# HYDRAULIC STEERING BLEEDER NUT DEFECTS

Through in house testing, Teleflex Marine has found an isolated failure of Bleeder Nut part # 794926, where it has cracked due to stress corrosion. All Bleeder Nuts that have been assembled with SeaStar or BayStar Cylinders, SeaStar Power Assist Pumps or supplied in SeaStar/BayStar/Hynautic Fitting kits between **March 1st, 2007 and June 30th, 2007** **MUST** be replaced prior to the next use of the vessel. Although very few of these Bleeder Nuts may have been shipped, and the likelihood of a nut cracking during use is extremely remote, Teleflex Marine feels it is prudent to replace ALL Bleeder Nuts immediately.

Figure 1a

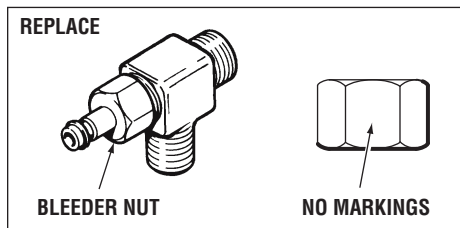
The Bleeder Nuts shown in Figure 1b have specific “Head Markings” that are stamped directly on the fitting and DO NOT need to be replaced. These marks identify the location of where the nut was manufactured. **ONLY** Bleeder Nuts that have **NO** markings will need to be replaced (refer to Figure 1a).

Figure 1c

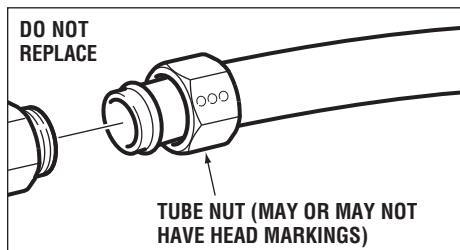
The following figures show the location of the “BLEEDER NUT” in relation to the unit it is installed on. We would like to stress that although similar in appearance, the “TUBE NUT” used to crimp SeaStar and BayStar Nylon Tubing onto a helm and/or cylinder (refer to Figure 1c), is NOT affected. To avoid unnecessary time and labor, ENSURE that ONLY the Bleeder Nut is replaced. Page 3 of this Advisory Notice has a complete list of all affected part numbers.

Figure A: Power Steering Cylinder

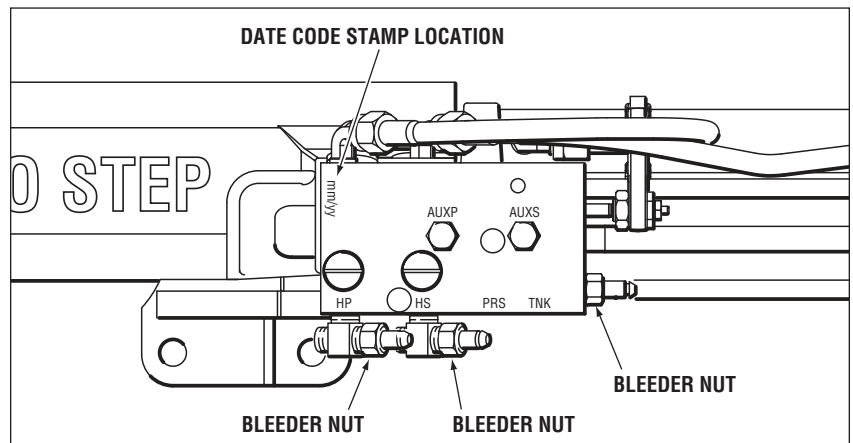
ALL Power Steering Cylinder will have 3 (three) Bleeder Nuts that may need to be replaced as per the markings listed above. A complete list of part numbers affected can be found on page 3 of this notice.

**Figure B: Power Assist Pump**

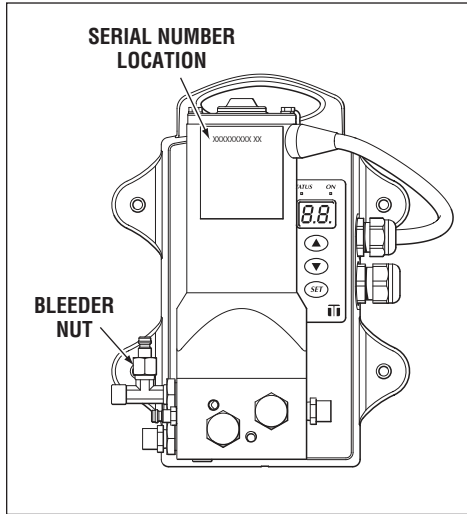
ALL Power Assist Pumps may have 1 (one) Bleeder Nut that will need to be replaced as per the markings on page 1 of this notice. A list of serial numbers of affected Power Assist Pumps can be found on page 3 of this notice.
